ADDENDUM # 3
March 15, 2024

Bon Heur Pump Station Rehabilitation
St. Clair Shores, Michigan

Project No. WWS-2022-007

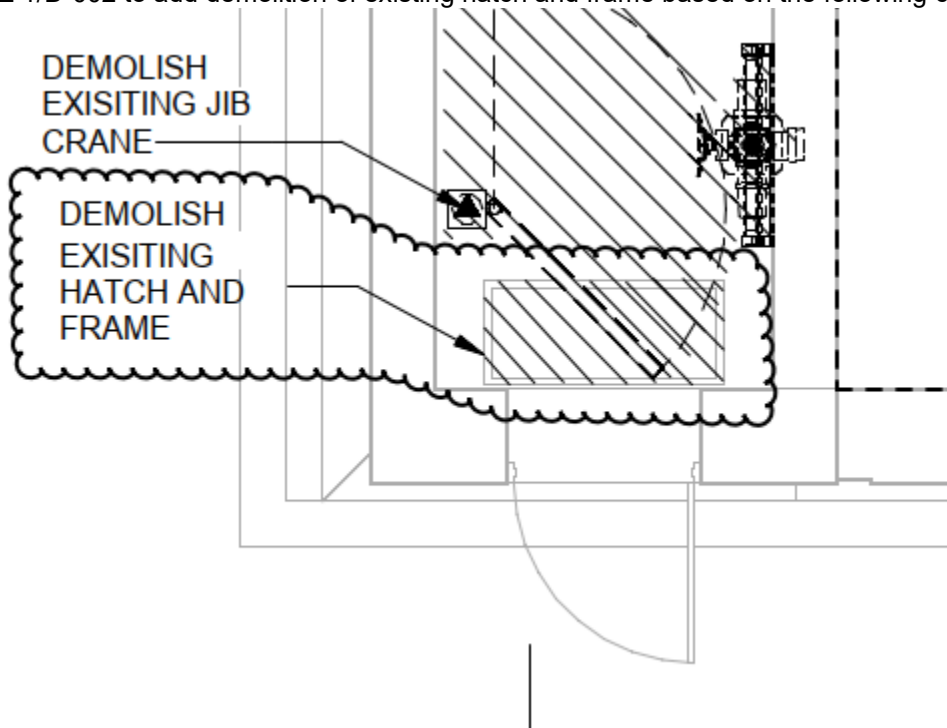
It is the intent of the Owner to add replacement of an existing floor hatch below the jib crane to the project:

REVISE 1/D-002 to add demolition of existing hatch and frame based on the following clip:

JIB CRANE REPLACEMENT PLAN AND SECTION

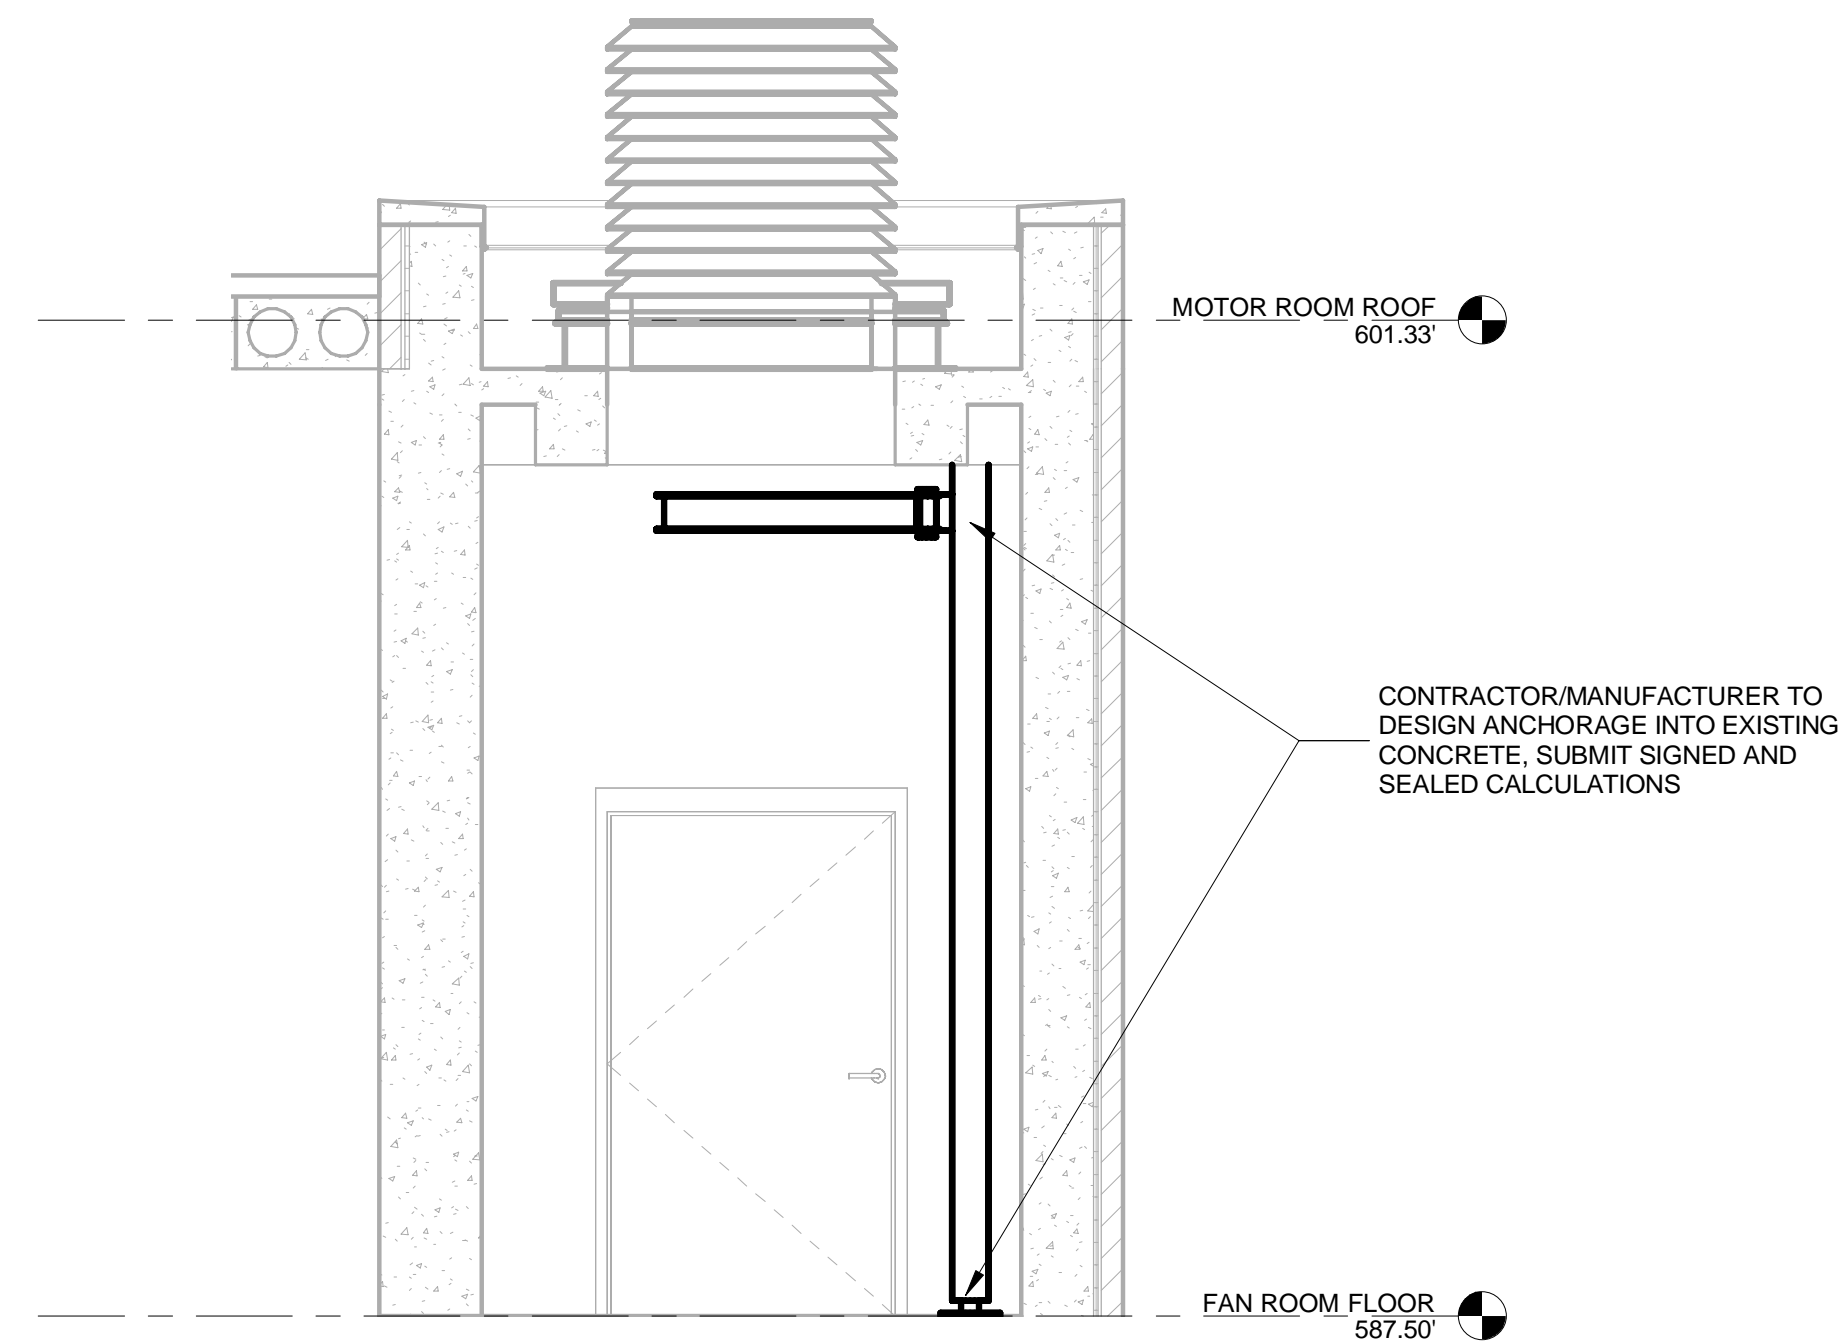
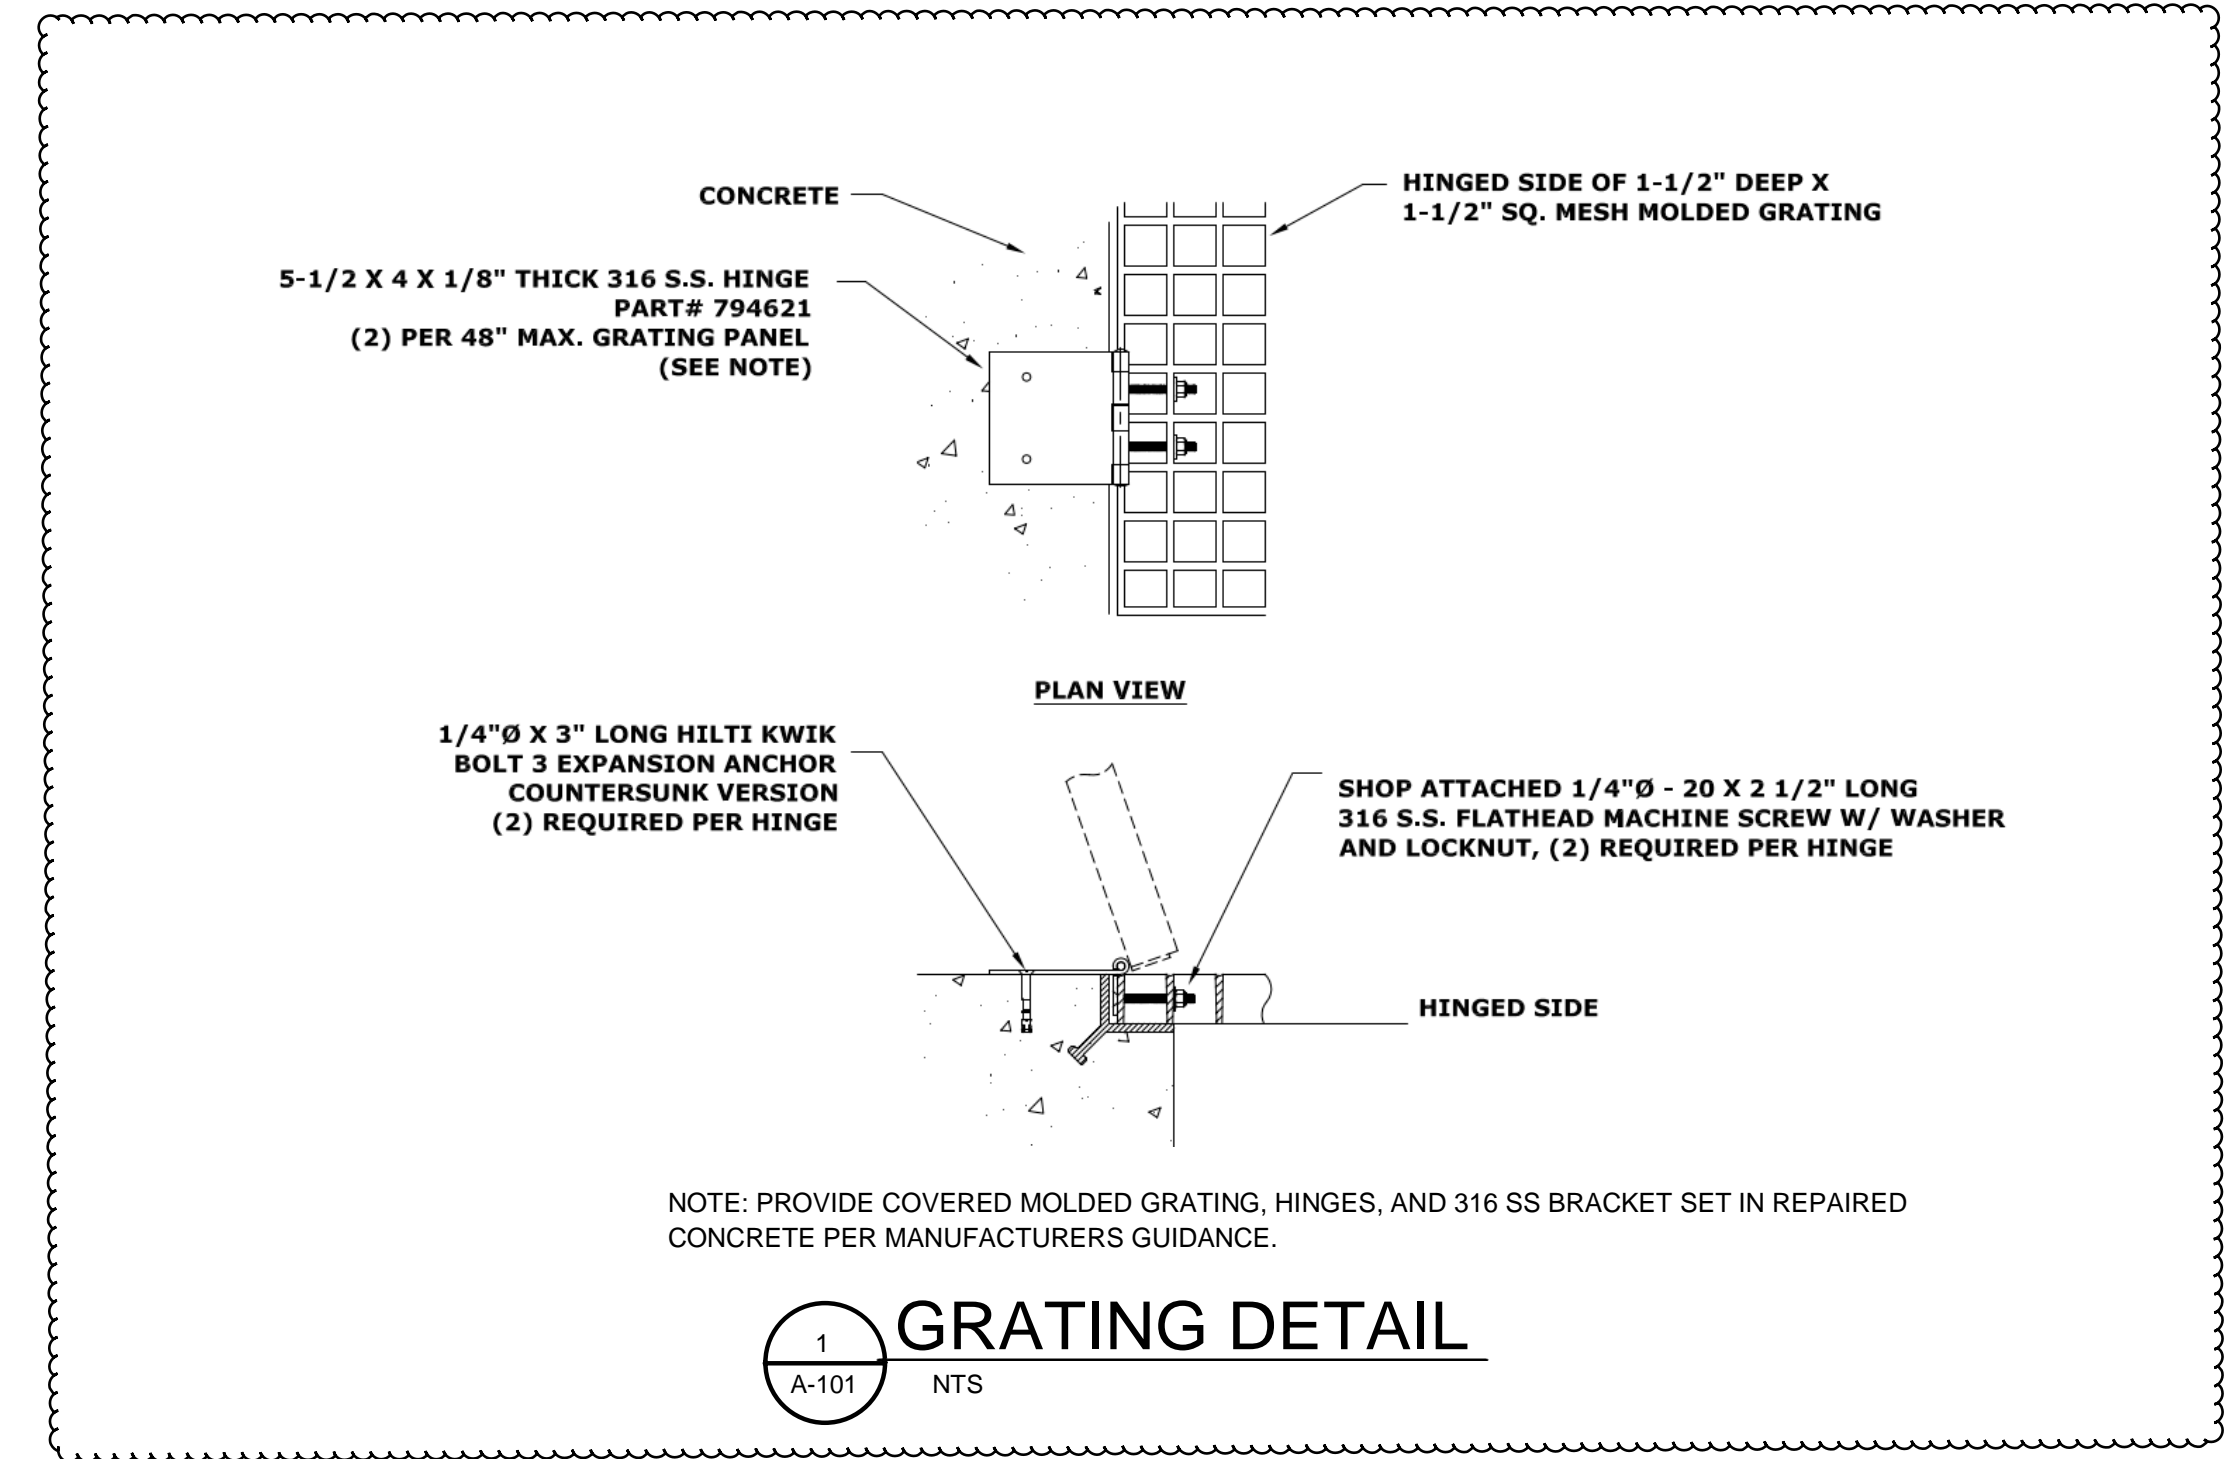
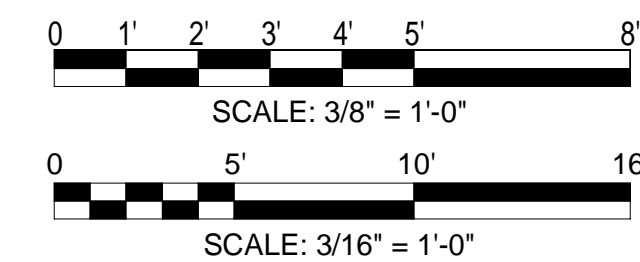
REPLACE sheet A-101 with the attached version showing proposed hinged covered grating.
